**Subject: COLUMBIA GENERATING STATION, DOCKET NO. 50-397
SUPPLEMENTAL INFORMATION REGARDING LICENSE AMENDMENT
REQUEST FOR CHANGING TECHNICAL SPECIFICATION TABLE 3.3.1.1-
1 FUNCTION 7, "SCRAM DISCHARGE VOLUME WATER LEVEL - HIGH"**

**SUPPLEMENTAL INFORMATION REGARDING LICENSE AMENDMENT REQUEST
FOR CHANGING TECHNICAL SPECIFICATION TABLE 3.3.1.1-1 FUNCTION 7,
"SCRAM DISCHARGE VOLUME WATER LEVEL - HIGH"**

RESPONSE TO SUPPLEMENTAL INFORMATION NEEDED

Figure 1 - Typical SDV Water Level - High Instrument Channel (Before & After)

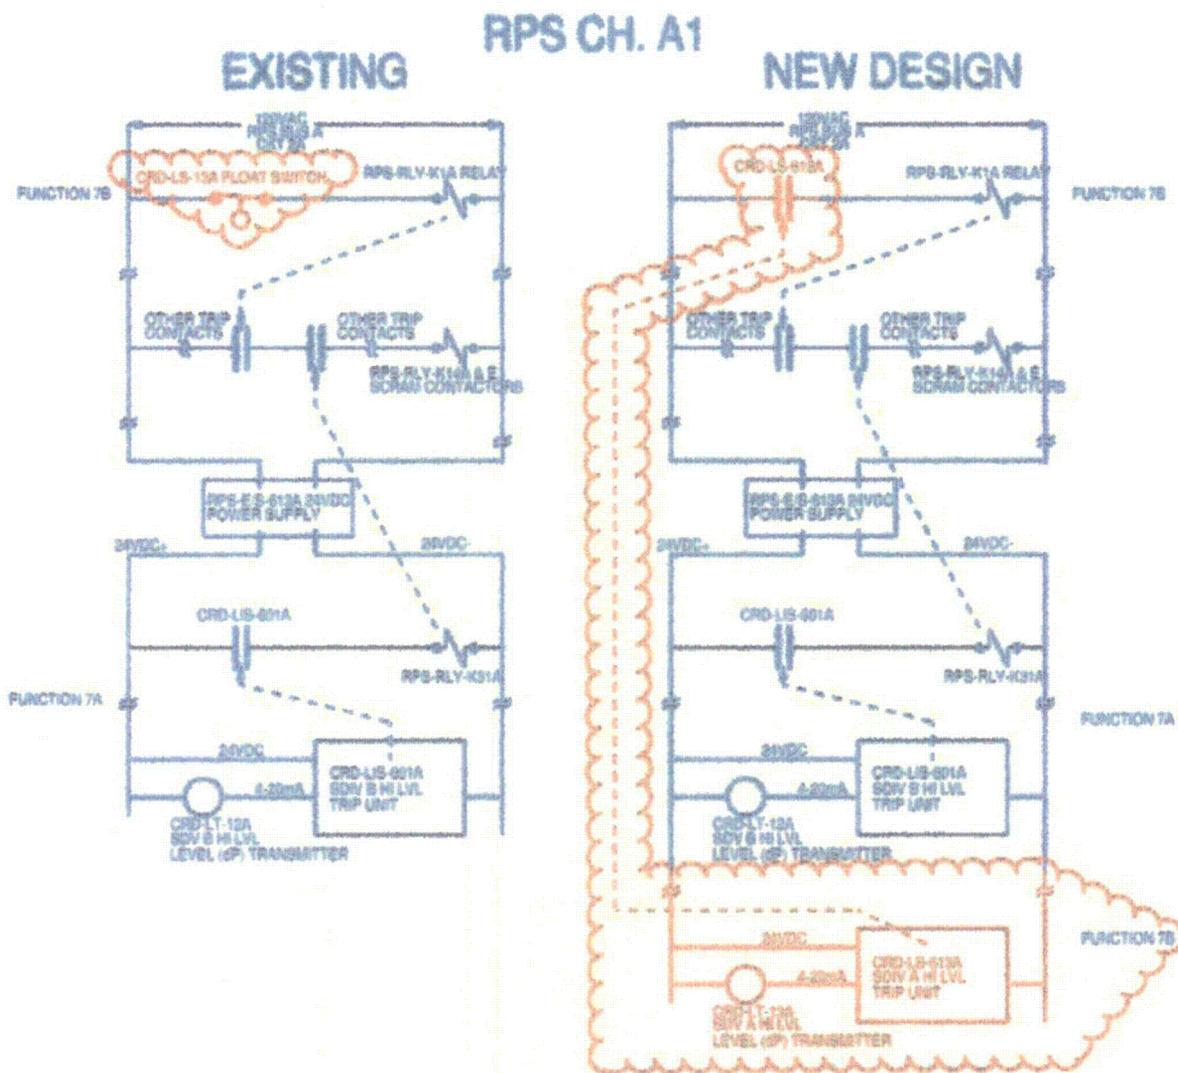
- a. Manufacturer and model of the level transmitter to be used for TS Table 3.3.1.1-1, Functions 7.a and 7.b. For Function 7.b, please provide a sketch of the typical instrument channel showing the "before change" and "after change" configurations.

The Technical Specification Table 3.3.1.1-1 Function 7.b sensing and trip signal design and logic configuration has changed, however the interface with RPS trip logic remains unchanged. The existing Function 7.b instruments are Magnetrol level switches (CRD-LS-13A, B, C, D) with associated relays that are the interface with the RPS Technical Specification Scram Function. After this change the functions that are now performed by the level float switches will be performed by new level transmitters and level switches (non-indicating trip units) (CRD-LT-13A, B, C, D and CRD-LS-613A, B, C, D).

This change replaces the instrumentation for the existing Magnetrol level switches with Rosemount 3152N Level Transmitters and the Ametek ET-1200 series non indicating trip units. The Rosemount 3150N Series pressure transmitters are electro-mechanical devices that convert a process pressure to an electrical output signal proportional to the pressure within a predetermined range of pressure values. The design uses an oil-filled cavity with a capacitance plate as the pressure-sensing element. Differential pressure changes result in a corresponding differential capacitance change in the sensing element (sensor). This signal is then decoded, amplified, and linearized by an analog circuit, converting the pressure change into a proportional 4-20mA electrical current

Figure 1 provides a sketch depicting a typical channel of the existing and new design for Function 7.b. There is no change to the RPS logic. Additionally, Figure 1 provides the typical channel for Function 7.a showing that channel logic remained the same.

Figure 2 - Setpoint Table for CRD-LS-613C, D Scram Setpoint

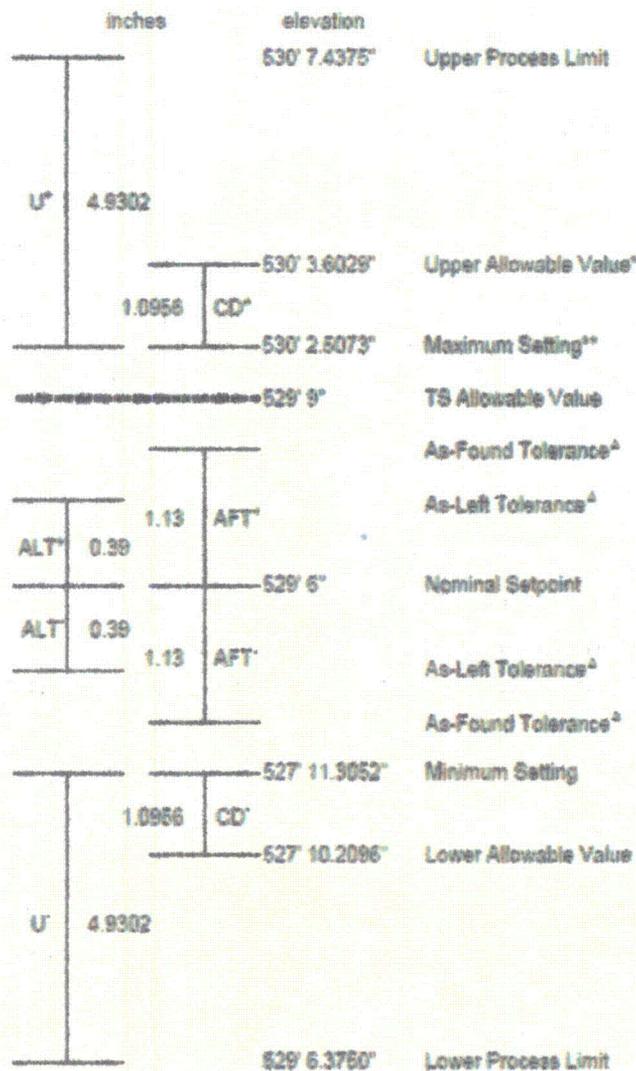
Implementation of TSTF-493, Note 1 requires the licensee to calculate appropriate magnitudes for ALT and AFT. Please provide information necessary to confirm that the AV remains the same, and provide a description of the methodology used to calculate the As-Left Tolerance (ALT), and As-Found Tolerance (AFT). Also, please provide a summary setpoint calculation for Function 7.b, and supporting design input data, consistent with Regulatory Guide 1.105, Revision 3, "Setpoints for Safety-Related Instrumentation," December 1999 (ADAMS Accession No. ML993560062), and Regulatory Issue Summary (RIS) 2006-17, "NRC Staff Position on the Requirements of 10 CFR 50.36, 'Technical Specifications,' Regarding Limiting Safety System Settings During Periodic Testing and Calibration of Instrument Channels," dated August 24, 2006 (ADAMS Accession No. ML051810077).

Supporting design input data is provided in Tables 2.1 and 2.2 for level transmitters and trip units, respectively. Finally, a graphical summary of the calculation is presented in Figure 2 below.

* NOTE: The Instrument accuracy is specified from centerline of the diaphragm of the reference leg to centerline of the upper sensing diaphragm. This is the 100% range of the instrument. Any further increase above the centerline of the upper sensing diaphragm affects the accuracy of the measured value. Once the upper sensing diaphragm is fully submerged no further increase in level will result in a detected level change. Therefore, the upper allowable value is limited by design to the centerline of the upper sensing diaphragm. The upper sensing diaphragm centerline elevation for these transmitters is 529'-9". Therefore, an Upper Allowable Value of 529'-9" will be used; this is in agreement with the Tech. Spec.

** NOTE: With the upper allowable value of 529'-9" per Tech Specs, the maximum setting is 529'-7.9" (529'-9" - 1.0956").

Δ NOTE: The combined As Found Tolerances AFT+ and AFT- values for instruments CRD-LT-13C/CRD-LS-613C and CRD-LT-13D/CRD-LS-613D are 0.08 mA (1.13 inches H2O). The combined As Left Tolerances ALT+ and ALT- values for instruments CRD-LT-13C/CRD-LS-613C and CRD-LT-13D/CRD-LS-613D are 00.048 mA (0.39 inches H2O). Margin: Nominal scram setpoint assumed to be 529'-6".
